Origination Form

Proposed Revisions to a Standard Plans Index

Originator:	Turley, Joshua	Index Number:	521-650
Date:	4/11/2024	Sheet Number(s):	1,3
E-mail:	Joshua.Turley@dot.state.fl.us	Index Title:	LIGHT POLE PEDESTAL - WALL COPING

LIGHT POLE PEDESTAL NOTES:

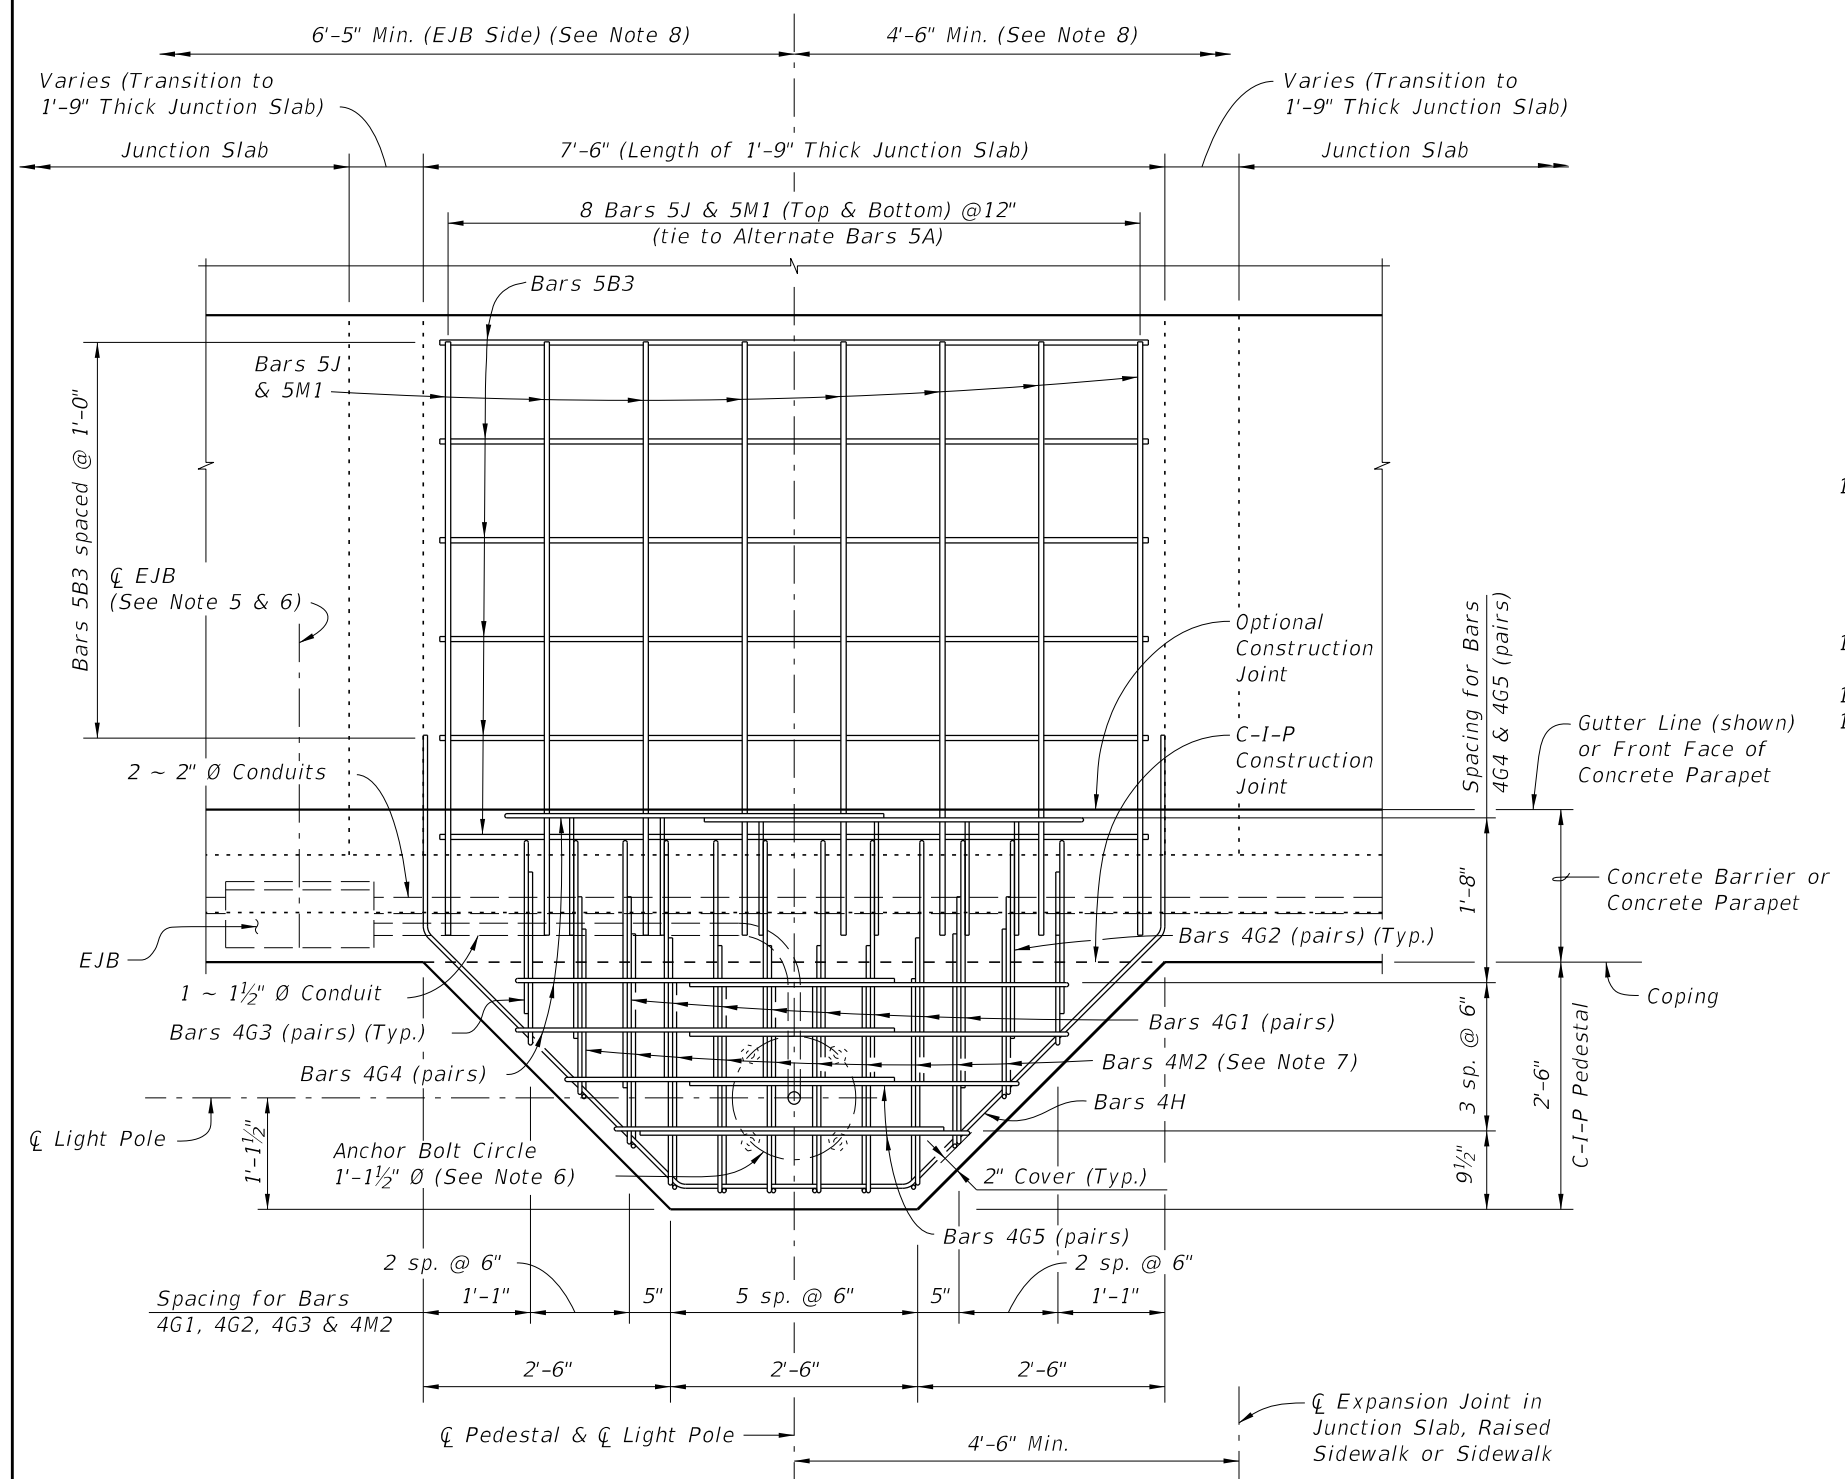
Sheet 1: Removed anchor bolt table; Revised note 1 to now include maximum deck height, pole height, and pole arm length
 Sheet 3: Added labeling to the Anchor bolt nuts in DETAIL "A"

Sheet 1: The anchor bolt table was removed so that this Index will only address the standardized pole and pedestal capacities. The pole mounting height is limited to 40 feet for an elevated structure mount.
 Sheet 3: Labels were added to correspond correctly with upcoming spec change to Spec 649.

- ANCHOR BOLTS:**
Anchor Bolt design is based on the standard Roadway Aluminum Light Pole configurations shown on Index 715-002 with top of pedestal 75' or less above ground or MLW.
~~Anchor Bolt Diameter: See Table 1~~

~~TABLE 1 DESIGN LIMITATION FOR ANCHOR BOLTS (1" Dia.)~~

with a maximum 40 ft luminaire mounting height and a maximum 12 ft arm length. Use 1" Ø anchor bolt for up to 75 ft bridge deck height above natural ground or MLW.

DETAIL "A"

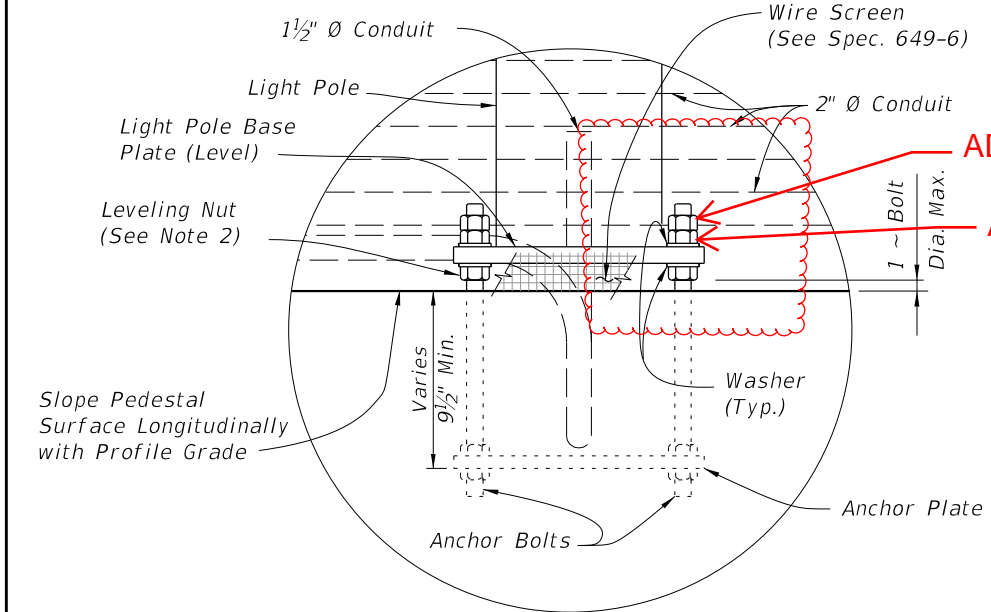
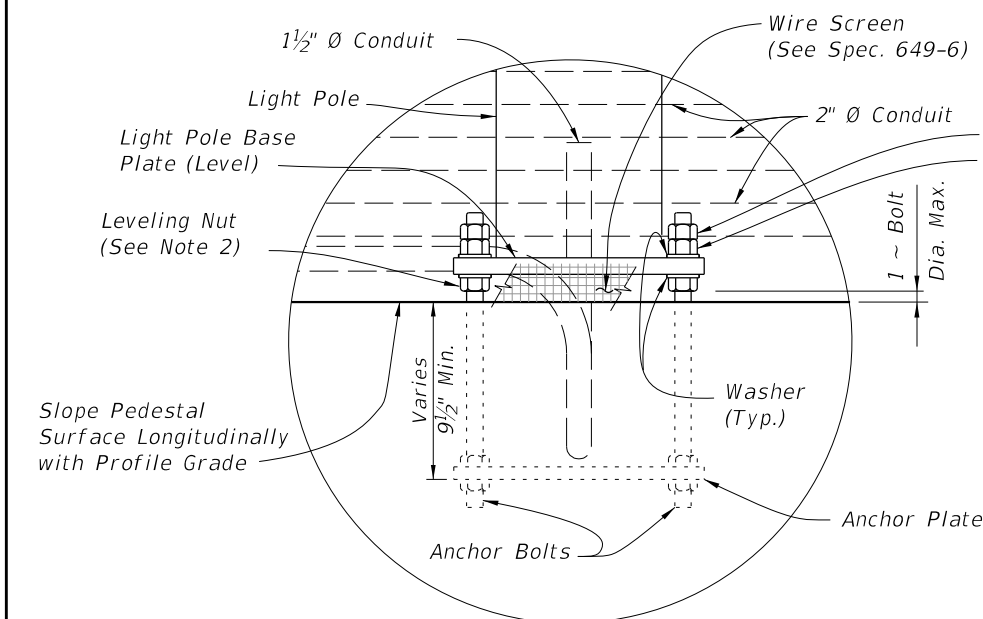
ADDED: Retainer Nut

ADDED: Anchor Nut
